Date Filed: November 7, 2024

City & County of San Francisco
BOARD OF APPEALS

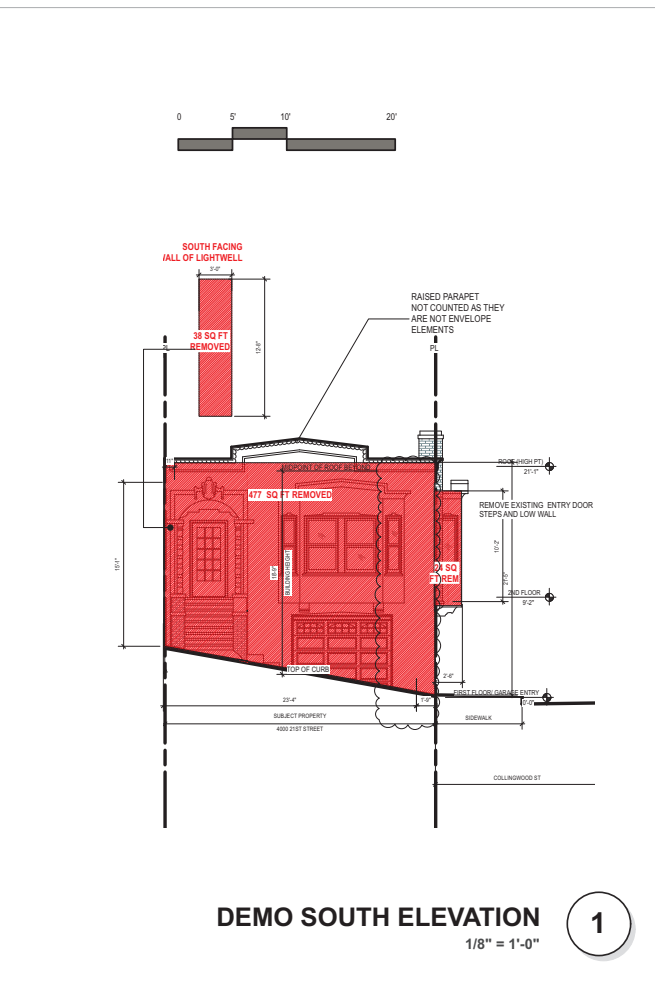
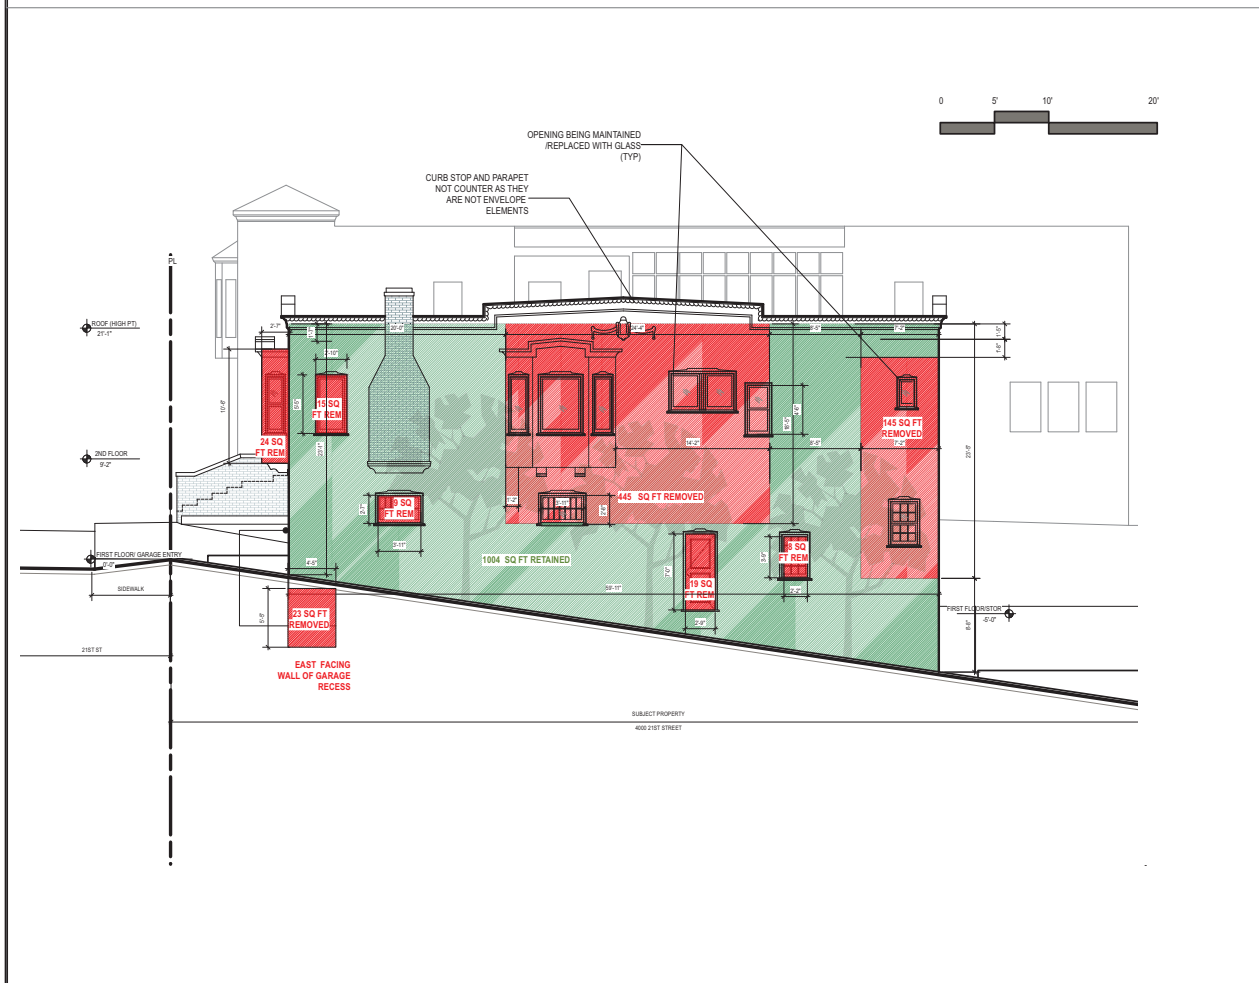
1 Per Section 317(b)(5), horizontal elements shall mean all roof areas and all floor plates, except floor plates at or below grade. Changing the level of an existing floor plate is considered "removal."
Removal of floor plates to accommodate a new stair is considered "removal."
2 Changing the level of an existing floor plate is considered "removal." Removal of floor plates to accommodate a new stair is considered "removal."
3 To use Section 317(b)(2)(a)(9) clause of "removed and replaced for repair or maintenance," Owner must provide documentation such as: 1) (During Design Review) an engineer's report to show existing is beyond repair and requires replacement, or 2) (During Construction) a "Correction Notice" issued by DBI to show requirement to repair.

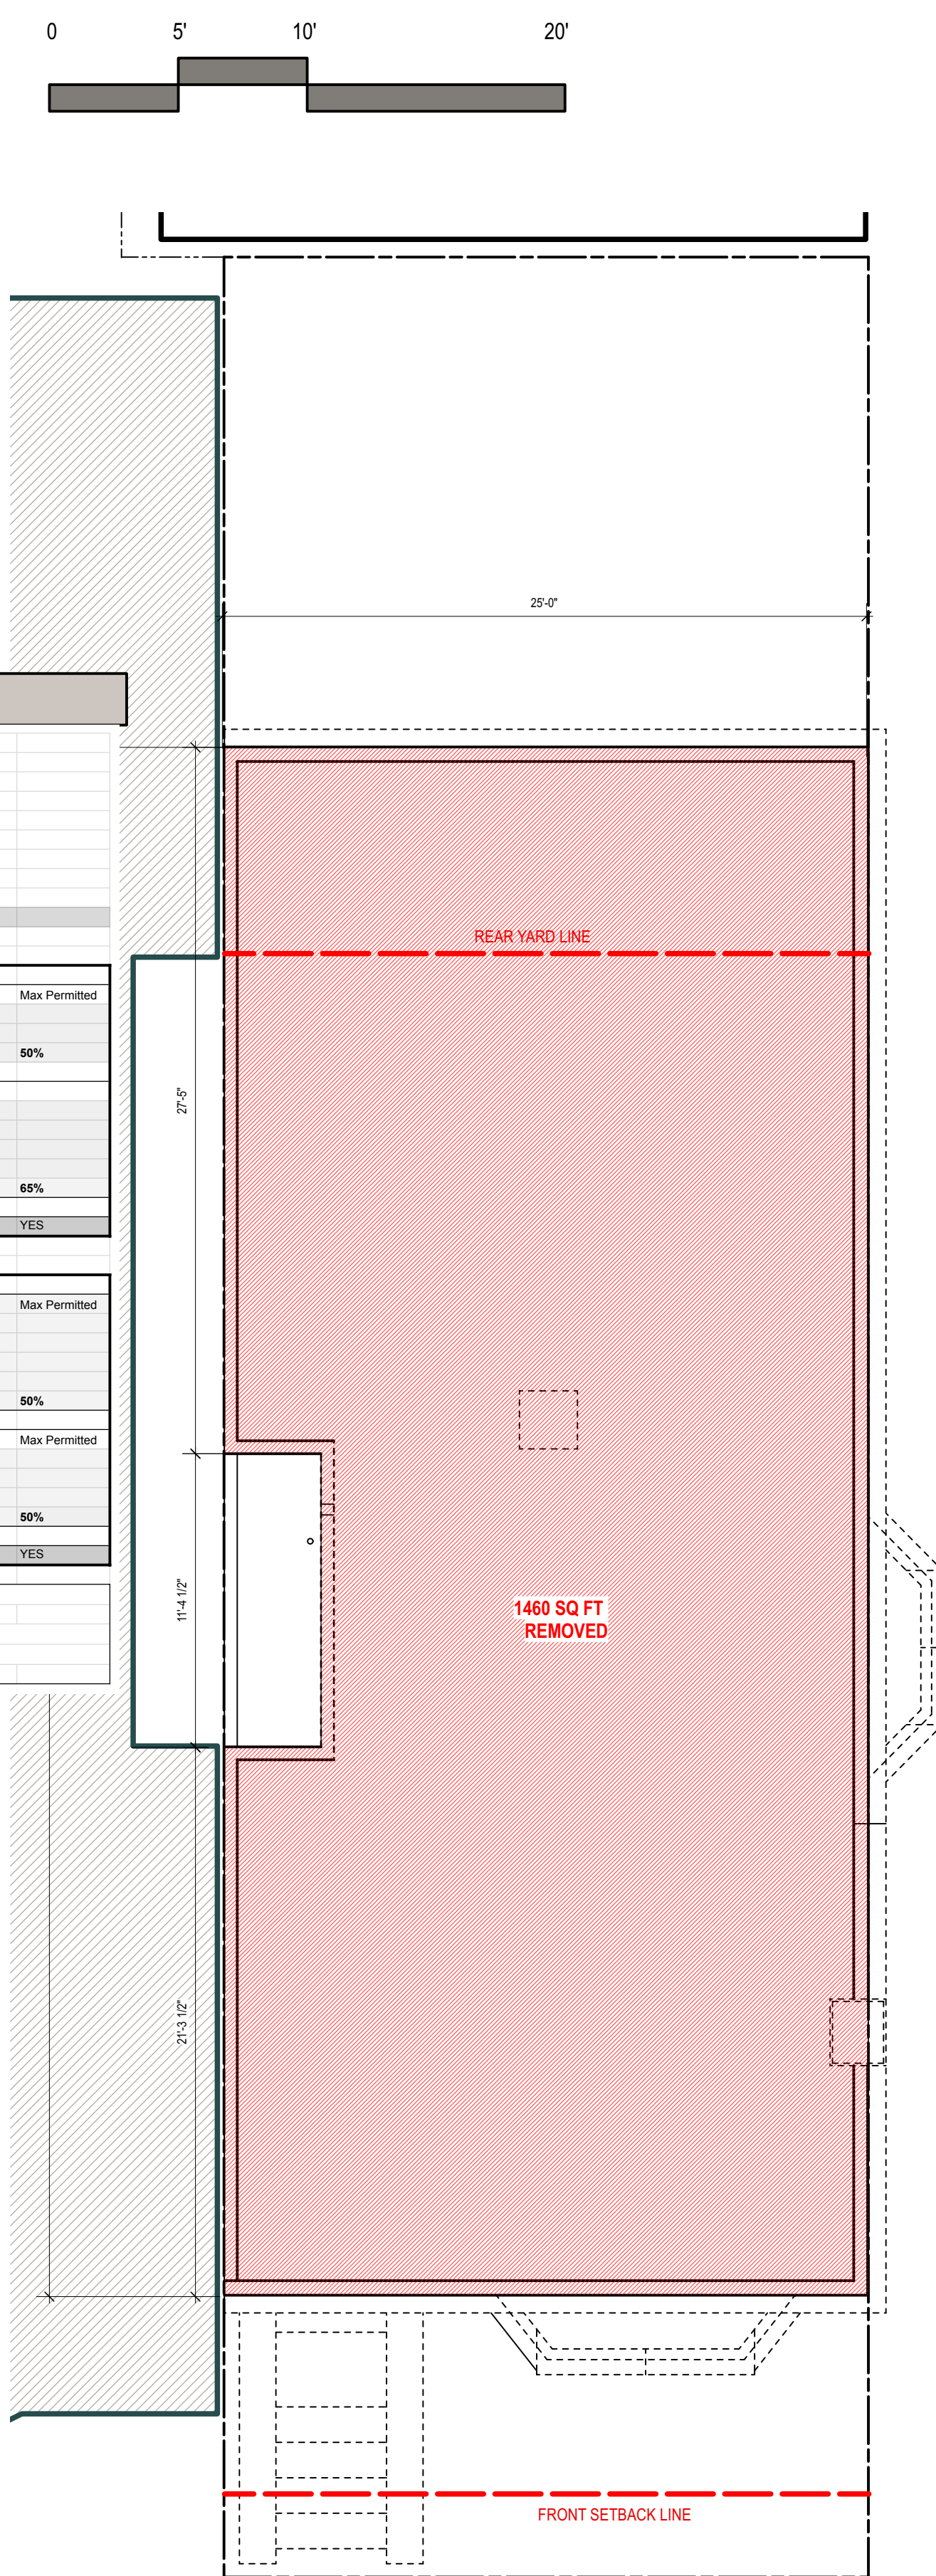
4 To use Section 317(b)(2)(d)(9) clause of "removed and replaced for repair or maintenance," Owner must provide documentation such as: 1) (During Design Review) an engineer's report to show existing is beyond repair and requires replacement, or 2) (During Construction) a "Correction Notice" issued by DBI to show requirement to repair.

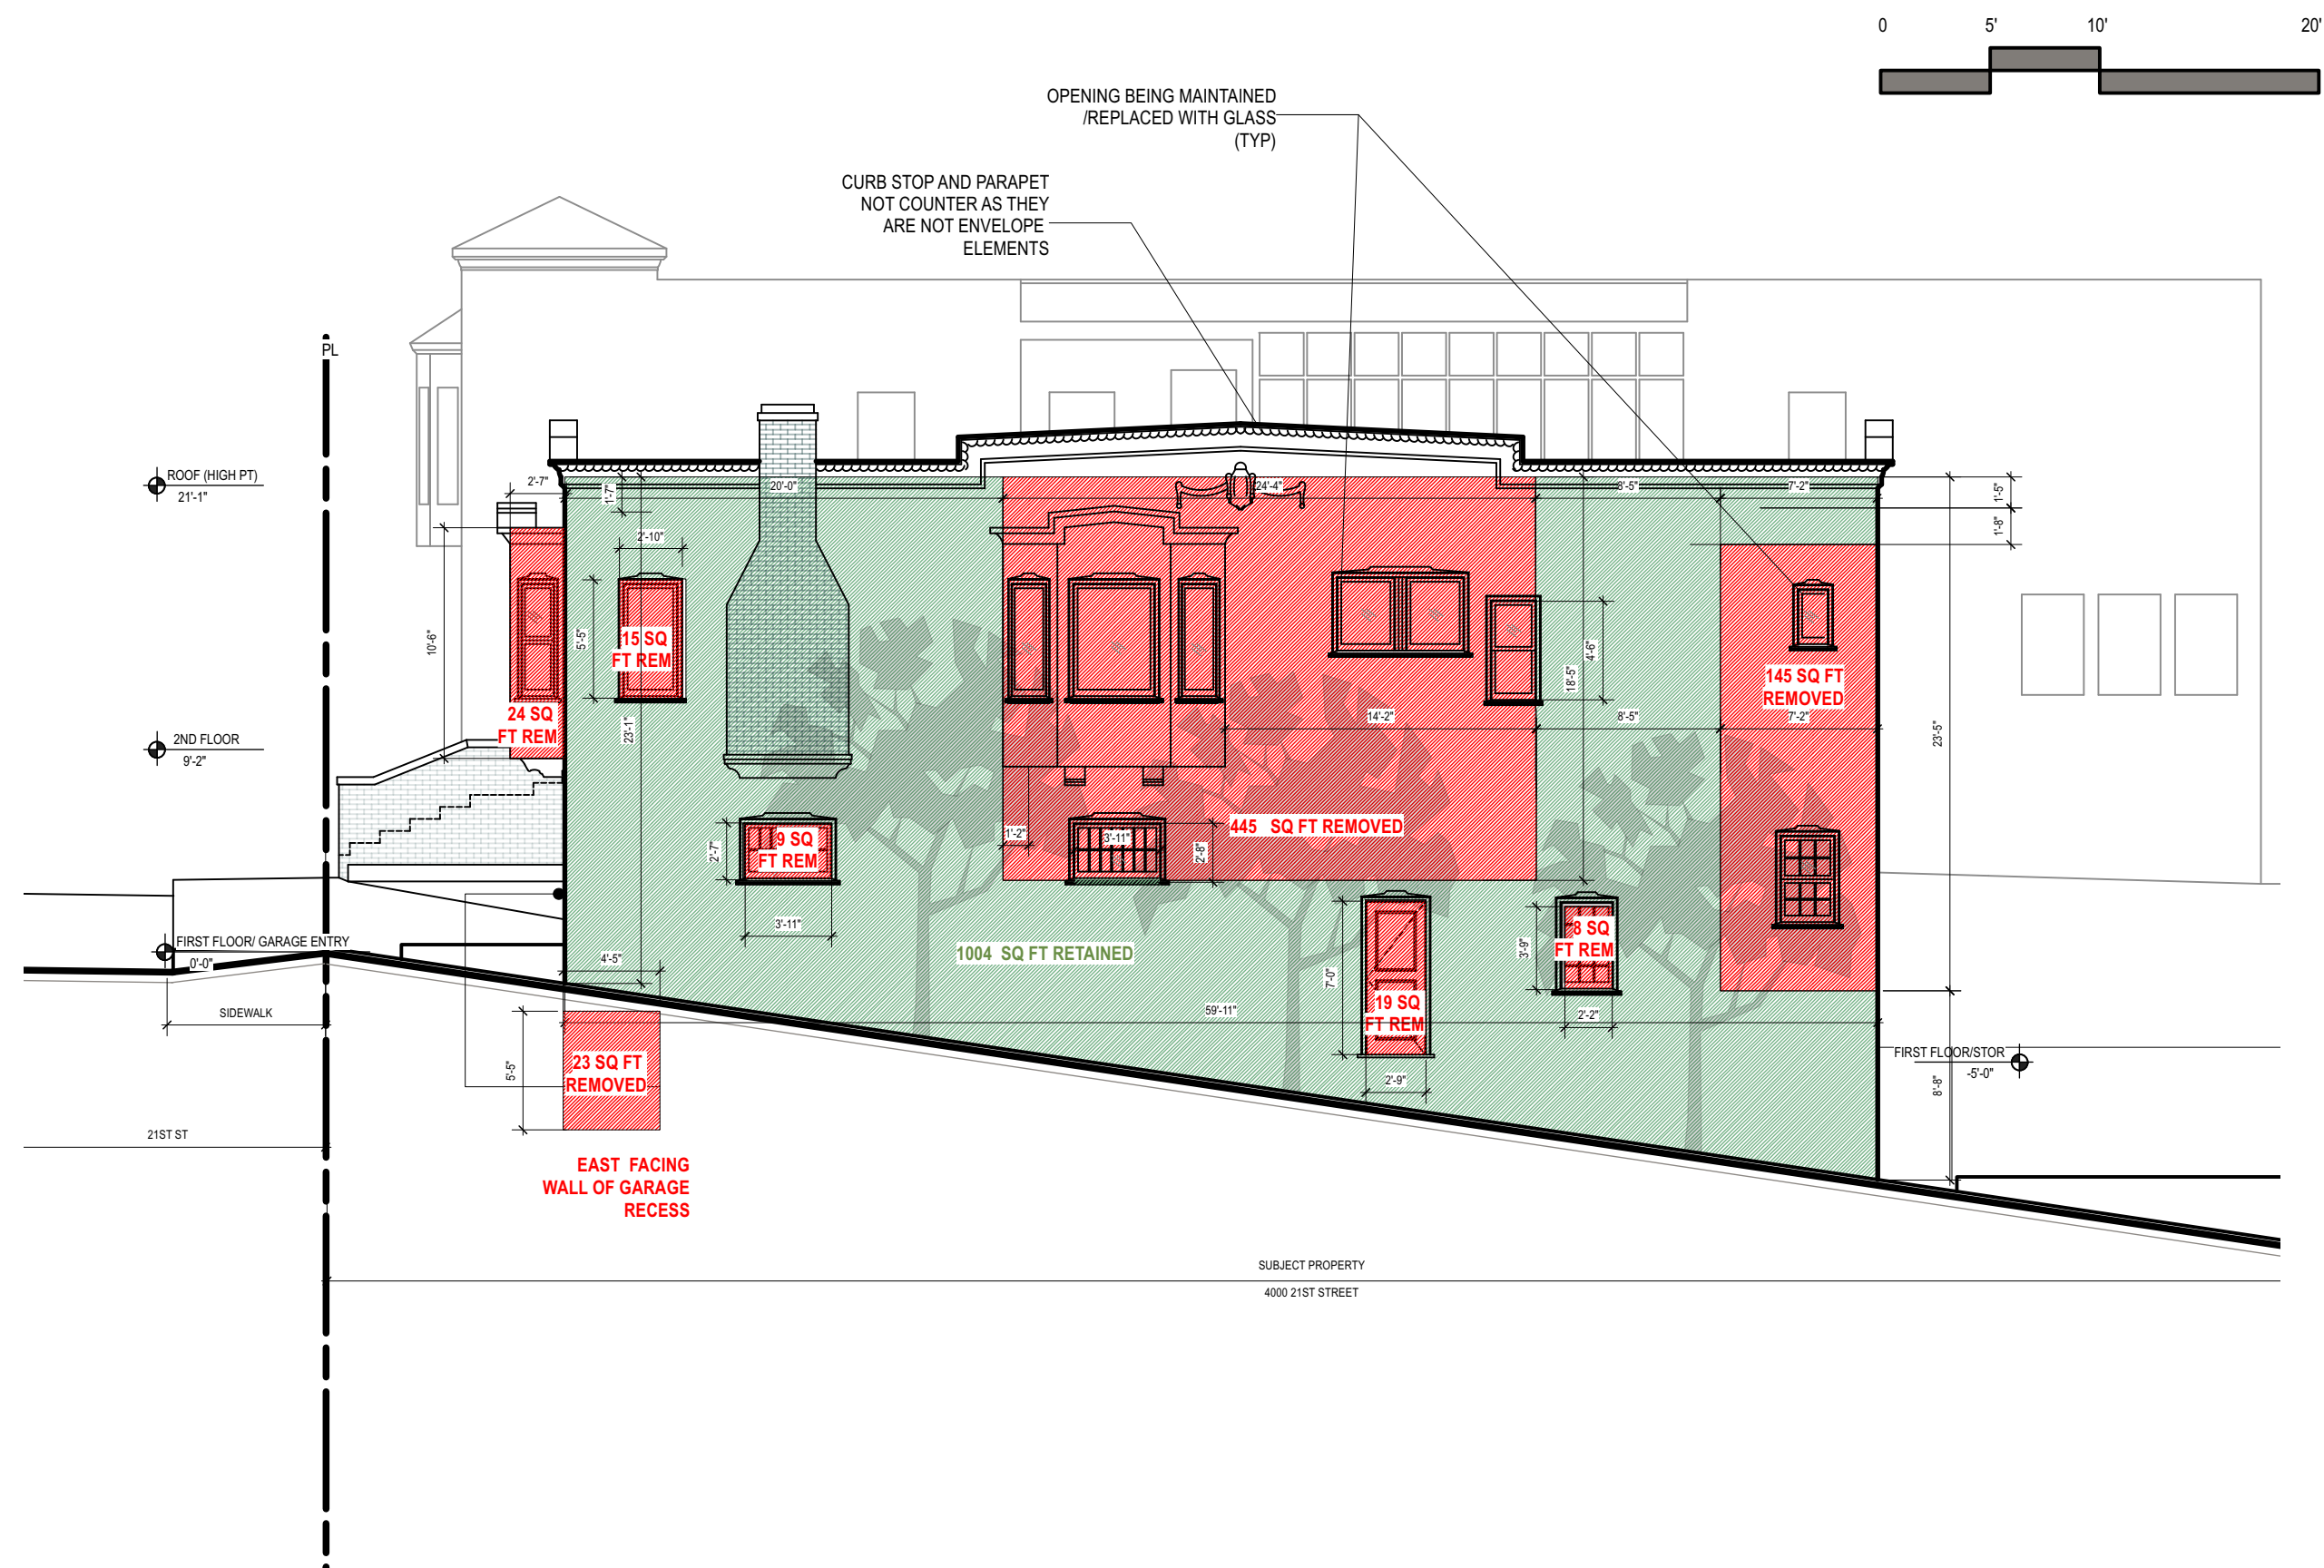
3 To use Section 317(b)(2)(i)(ii) clause of "removed and replaced for repair or maintenance," Owner must provide documentation such as: 1) (During Design Review) an engineer's report to show existing is beyond repair and requires replacement, or 2) (During Construction) a "Correction Notice" issued by DBI to show requirement to repair.

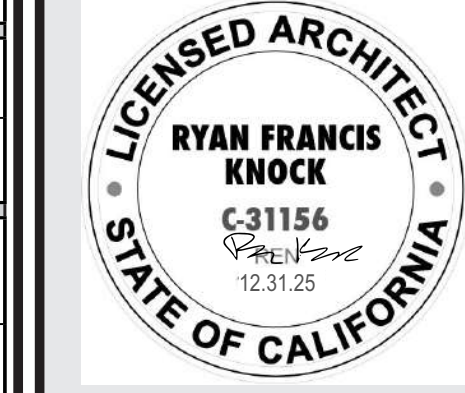
Indicate below who is responsible for ensuring green building requirements are met. Projects that increase total conditioned floor area by ≥1,000 sq. ft. are required to have a Green Building Compliance Professional of Record as described in Administrative Bulletin 93. For projects that increase total conditioned floor area by <1,000 sq. ft., the applicant or design professional may sign below, and no license or special qualifications are required. FINAL COMPLIANCE VERIFICATION form will be required prior to Certificate of Completion
